REMEDATION SYSTEM EVALUATION

ELISKIM FACILITY  
ANDERSON COUNTY, SOUTH CAROLINA

Report of the Remediation System Evaluation,  
Site Visit Conducted at the Eliskim Facility, Anderson County, South Carolina  
April 29, 2003

EPA 542-F-04-024  
June 2004  
[www.epa.gov/tio](http://www.epa.gov/tio)  
[clu-in.org/optimization](http://clu-in.org/optimization)

**FIGURE 1-1. THE ELISKIM PROPERTY, DOWNGRADIENT AREA, AND MONITORING WELL LOCATIONS INDICATING TCE CONCENTRATIONS FROM THE 2002 SAMPLING EVENT.**

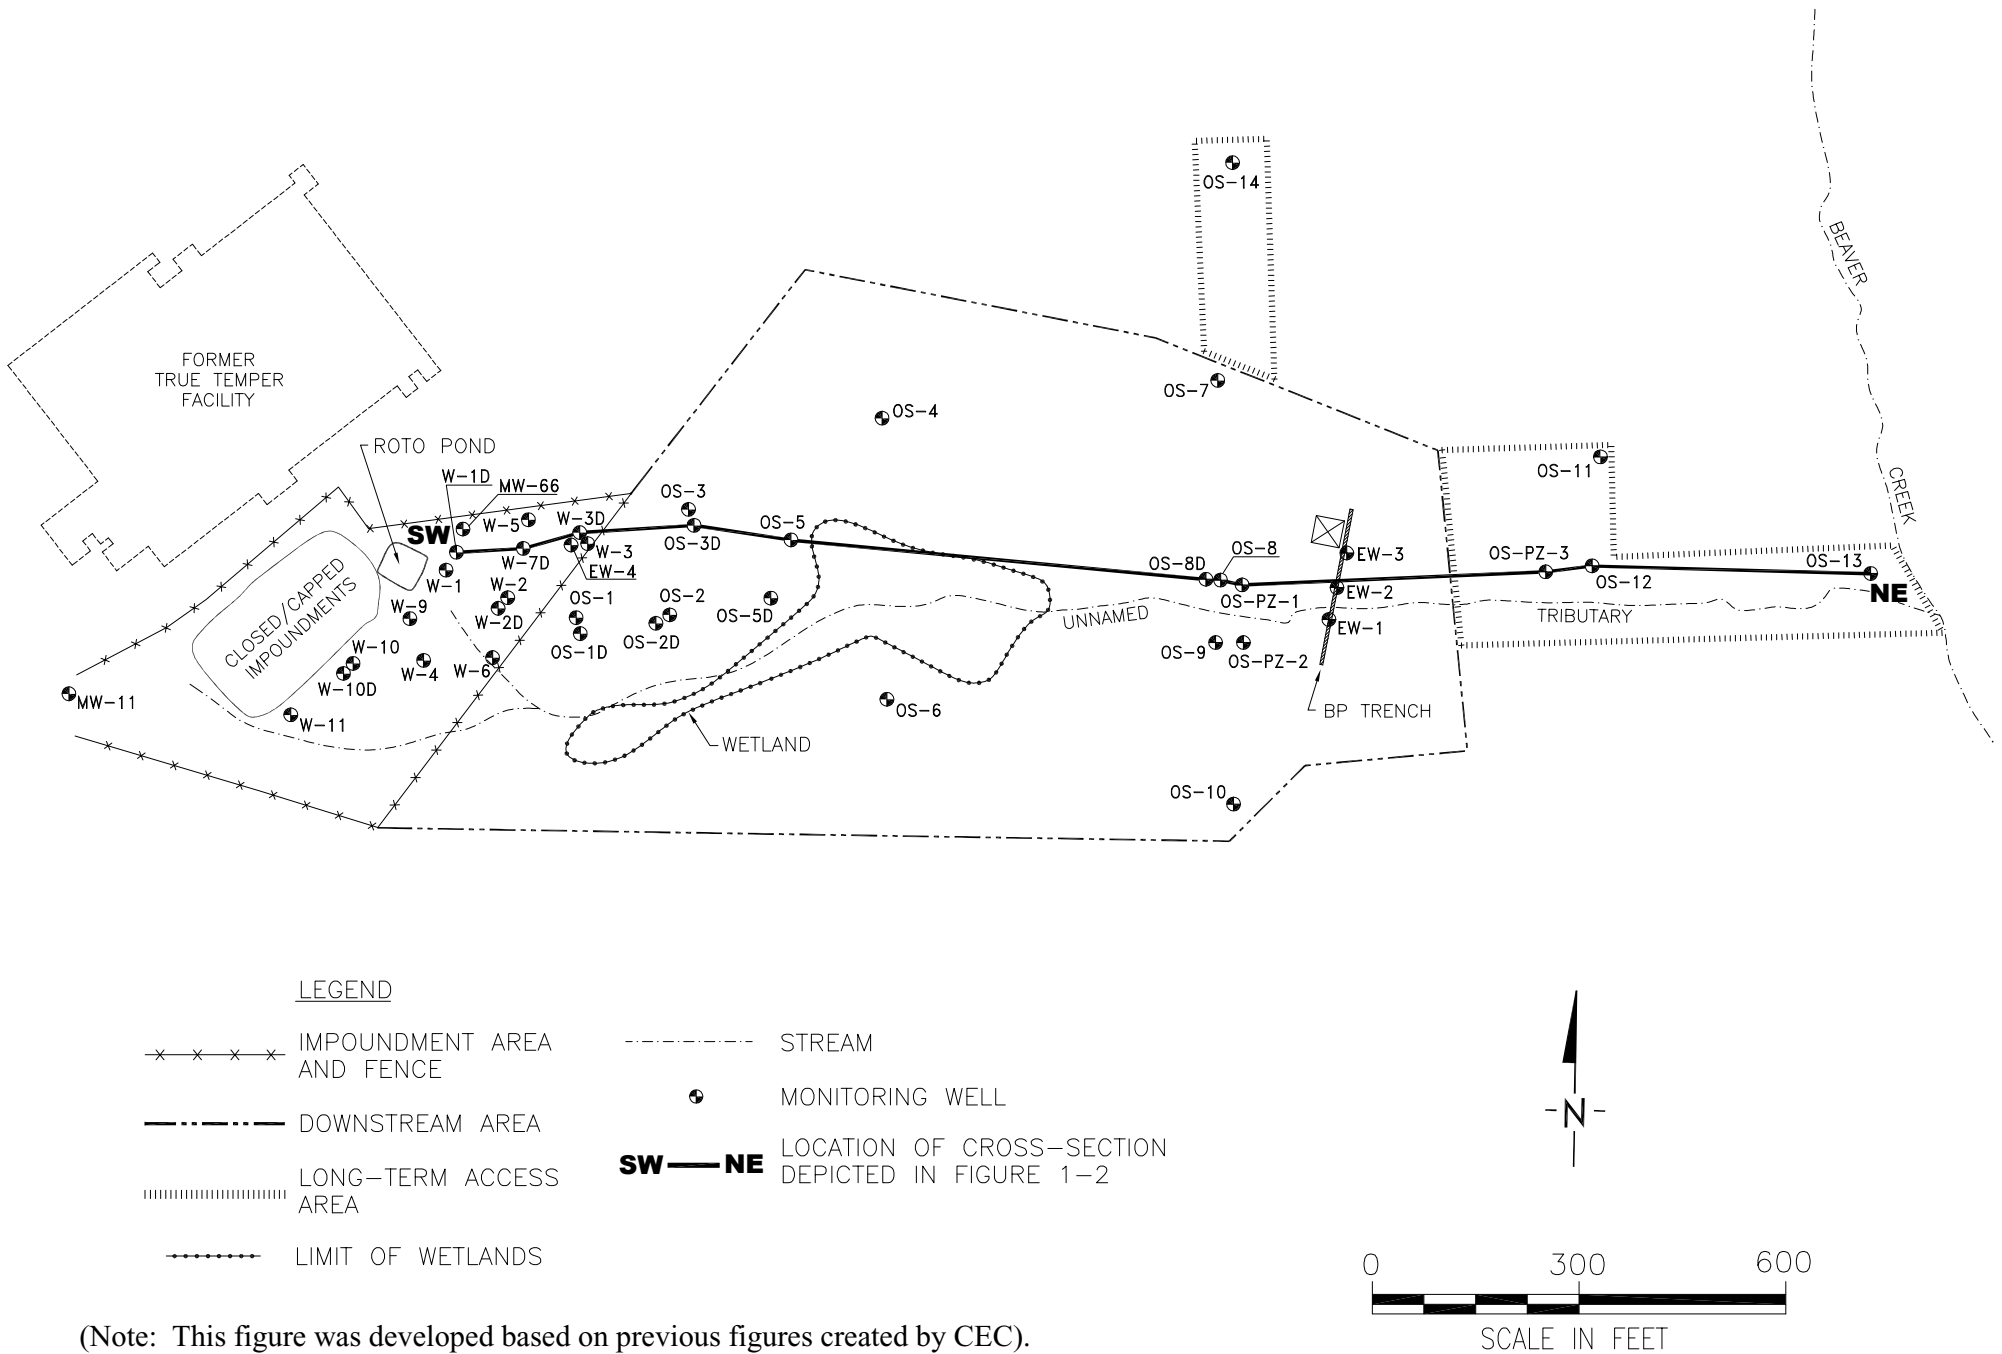
The Eliskim site is a closed hazardous waste management facility located approximately one mile south of Anderson, South Carolina. Key land parcels are illustrated on Figure 1-1. The original facility (the “Impoundment Area”) consisted of approximately five acres of property with ponds and lagoons used for hazardous waste management associated with a plant originally owned by True Temper that was located on an adjoining parcel. The plant was sold to Emhart Corporation in 1985, and is currently operating as a truck depot. An additional 20 acres east of the Impoundment Area (the “Downstream Area”) was purchased as part of the ground water remediation. A ground water collection trench and a treatment plant are located on this 20-acre parcel. The property north, east, and south of the Downstream Area is owned by Mr. Joseph Nehme (the “Nehme Property”), and that property contains several monitoring wells that are monitored and are accessible under access agreements.

As illustrated on Figure 1-1, two drainage ditches channel runoff from the former True Temper plant property and the capped area to form the unnamed tributary to Beaver Creek. Beaver Creek is located approximately 2,000 feet northeast of the original 5-acre facility.

The depth of VOC contamination has not been defined below OS-5D and OS-8D. Vertical delineation may also be incomplete near W-7D.

FIGURE 1-2. SOUTHWEST/NORTHEAST CROSS SECTION DEPICTED ON FIGURE 1-1.

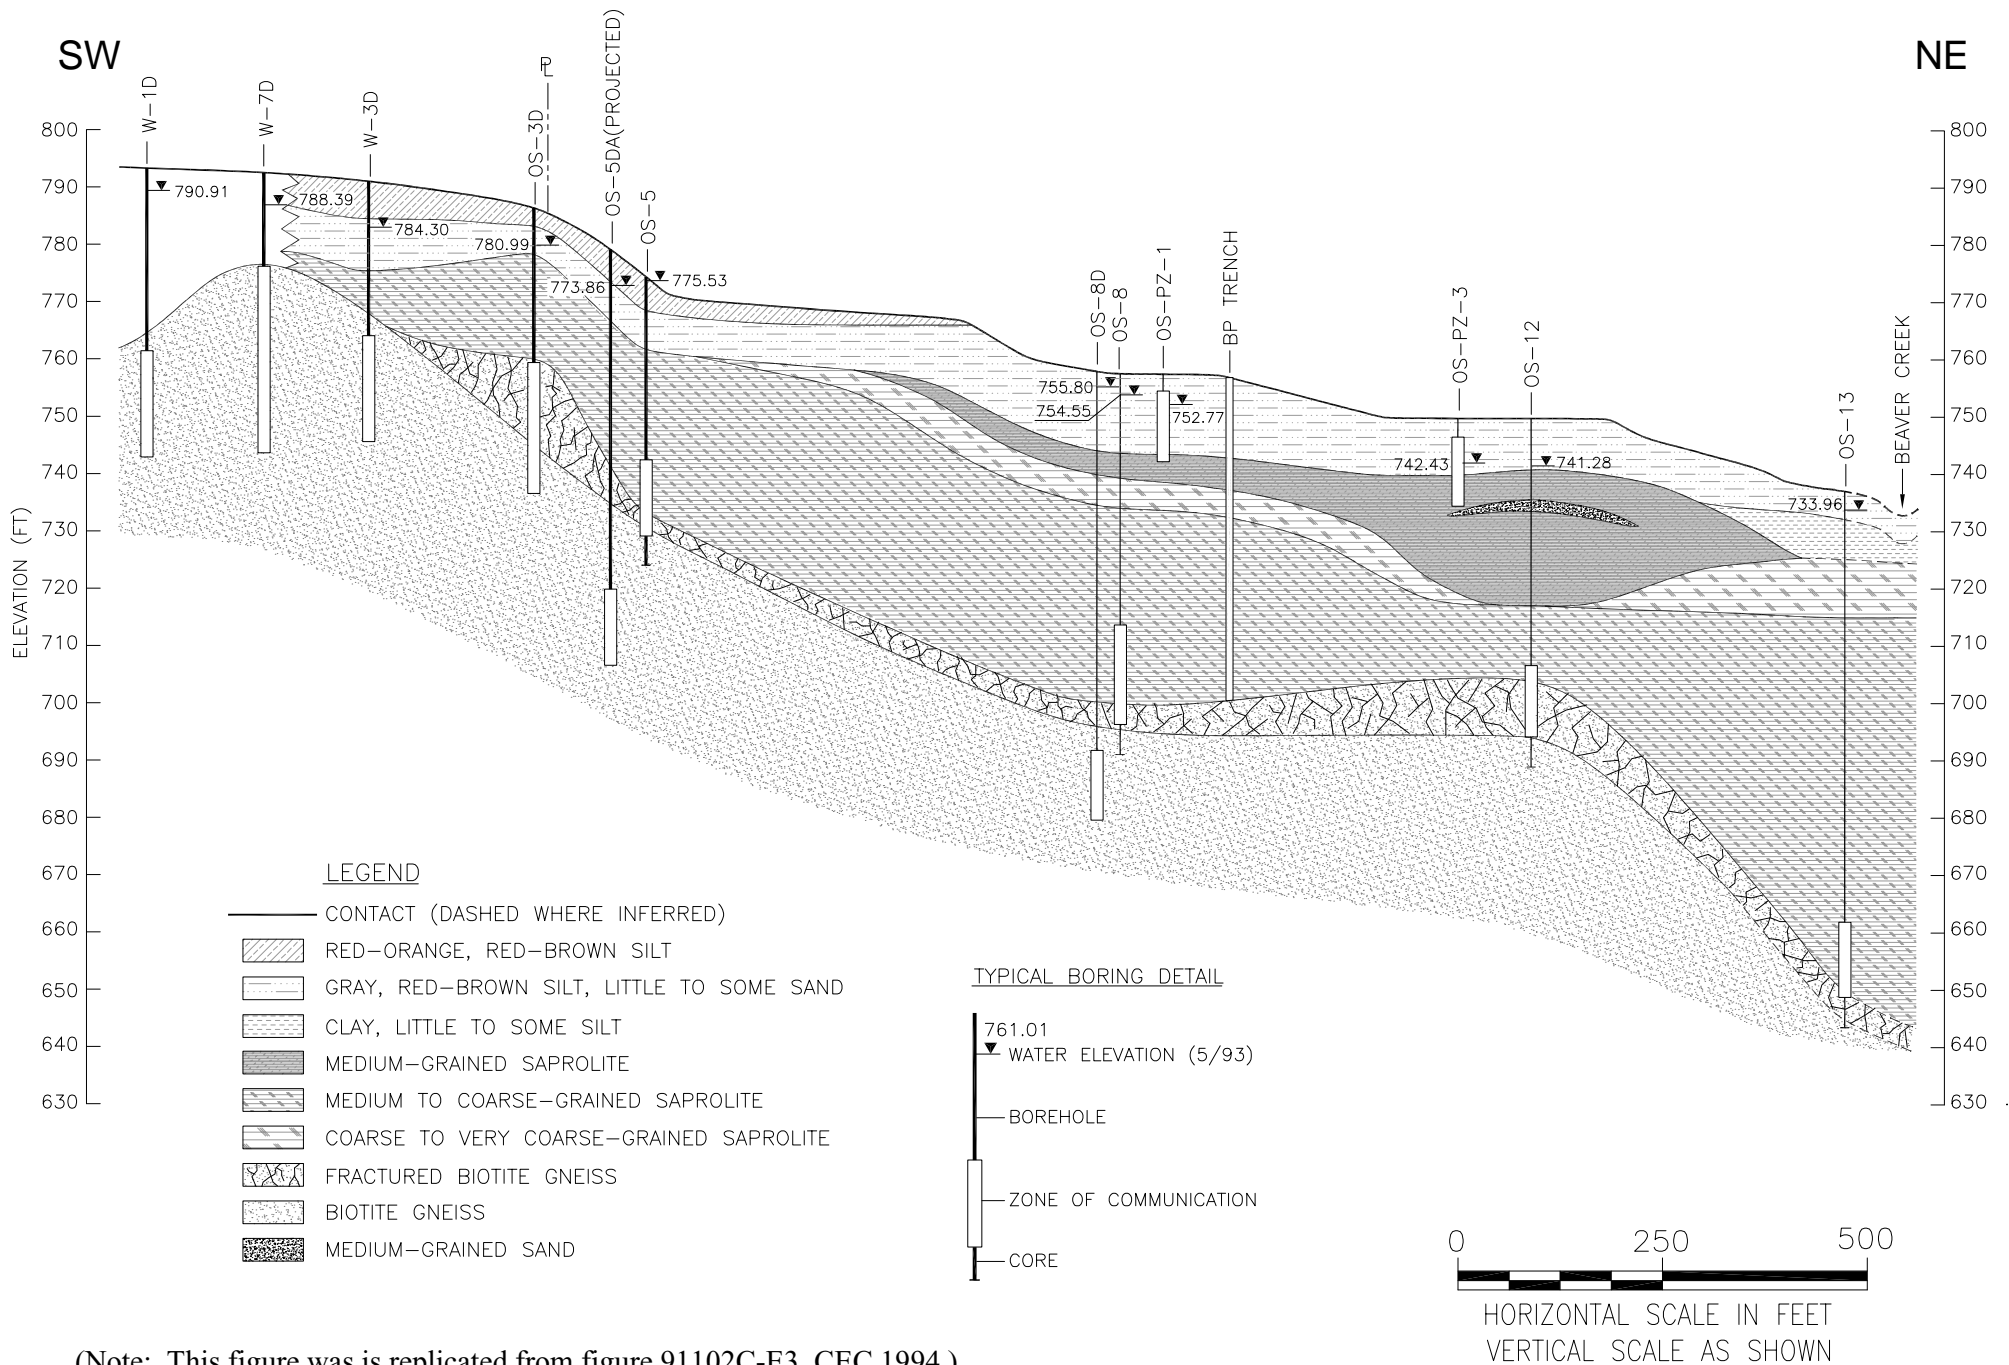
The site is located in the Piedmont physiographic province. Bedrock beneath the site is a biotite gneiss which is overlain by overburden (saprolite which grades from weathered bedrock to silty clay and clayey silt). The contact between competent bedrock and overburden is not well defined. Competent bedrock has been observed onsite at depths ranging from 10 to 51 feet, and at depths up to 88 feet beneath areas along the unnamed tributary. A geologic cross-section is shown in Figure 1-2, and the location of that cross-section is indicated on Figure 1-1.
